APPLICATION FOR PERMISSION
UNDER SECTION 16 OF THE TOWN PLANNING ORDINANCE

APPLICATION NO. A/H20/195

- (b) Minor relaxation of the PR/BH restrictions may be considered by the Town Planning Board (the Board) on application
- Application** : Proposed Minor Relaxation of PR for Permitted Non-polluting Industrial Use

參考編號 REFERENCE No. A/H20/195	繪圖 DRAWING A - 1
------------------------------------	------------------------

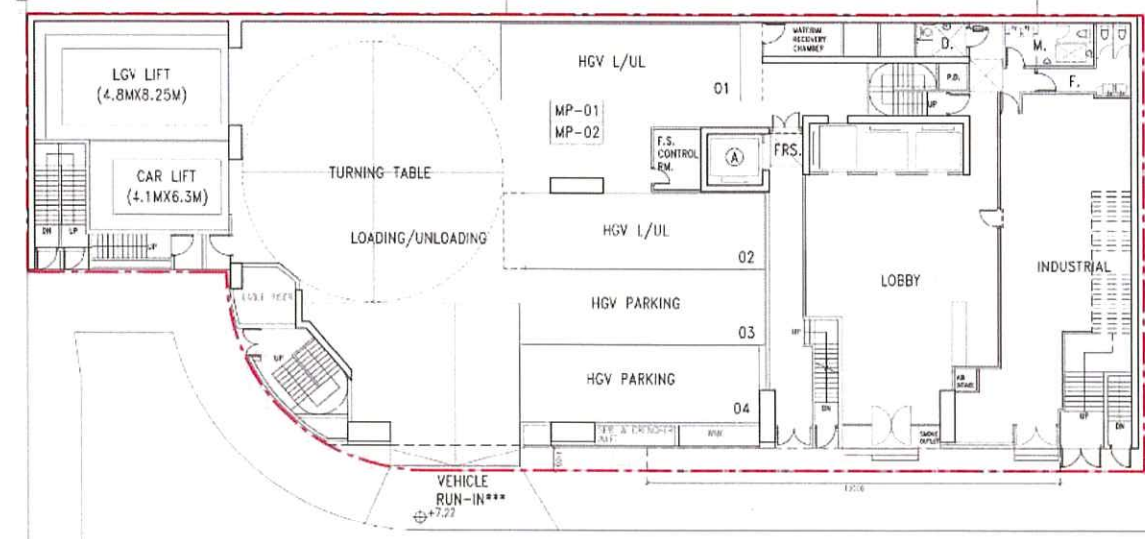
- (c) in the current proposal, the first two floors of the proposed development are for M&E, L/UL area and lobby, which may fit the intended functionality of the proposed development but will not contribute much to the public realm/pedestrian environment. Given that there is a wide range of permissible uses within the "OU(B)" zone that would help activate the street frontage, the applicant may consider designing the building in a way that allow for flexibility to accommodate future change of building uses on the lower floors.

繪圖
DRAWING
A - 7

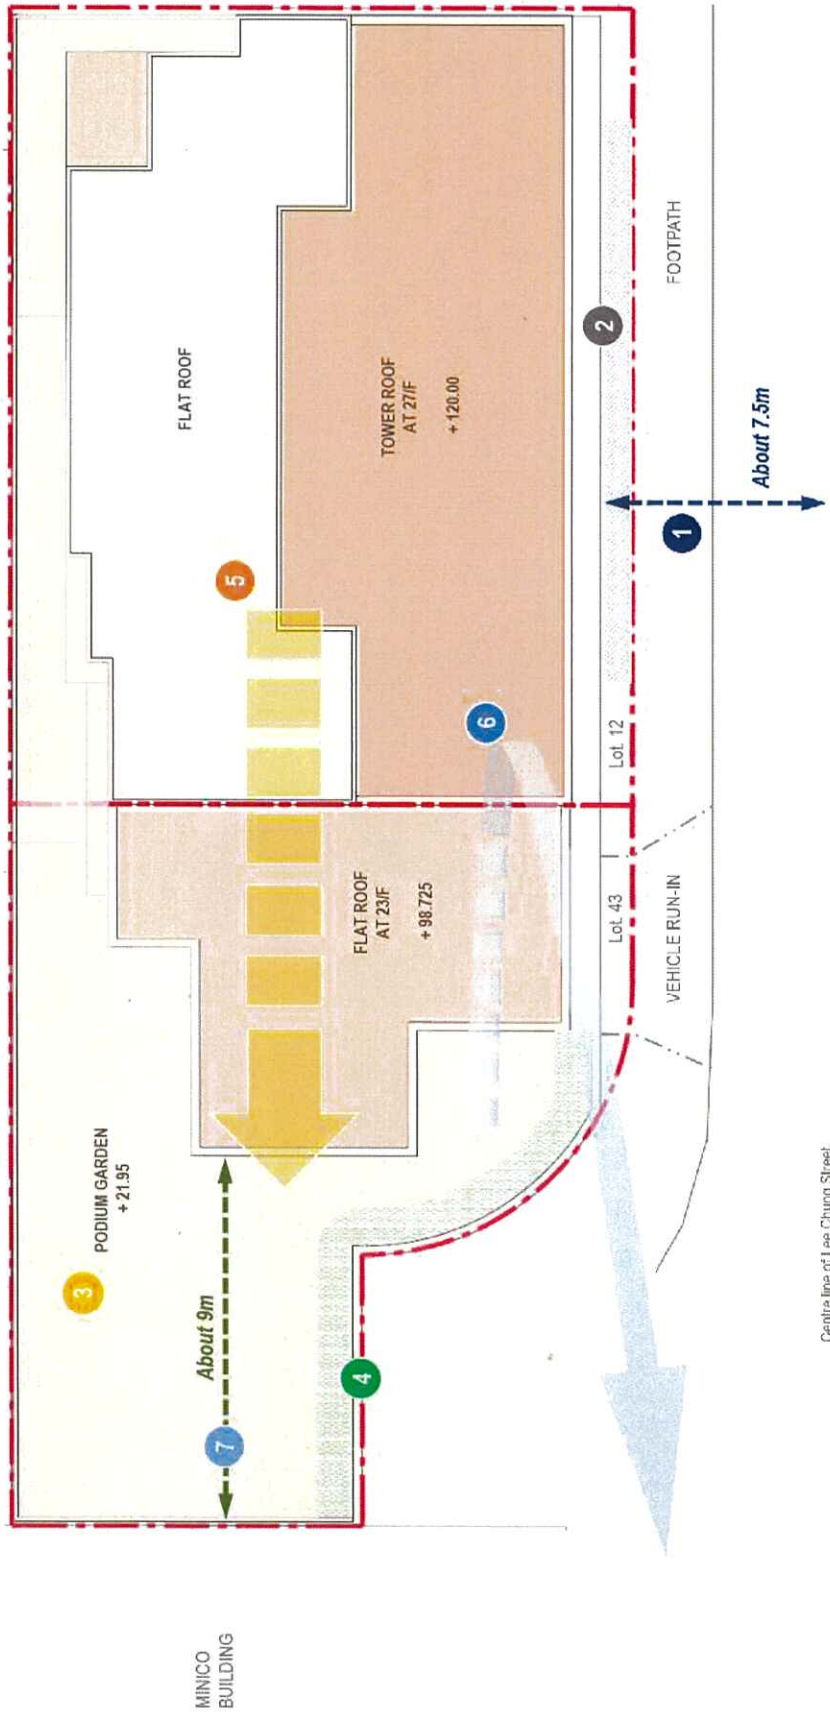
planting, stepped height of 120mPD and 98.725mPD and a podium garden at 21.95mPD (**Drawing A-7**), and a weather canopy along part of the frontage facing Lee Chung Street. Although technically speaking, incorporation of these design measures do not necessarily require additional PR, they represent the applicant's effort in building design improvement;
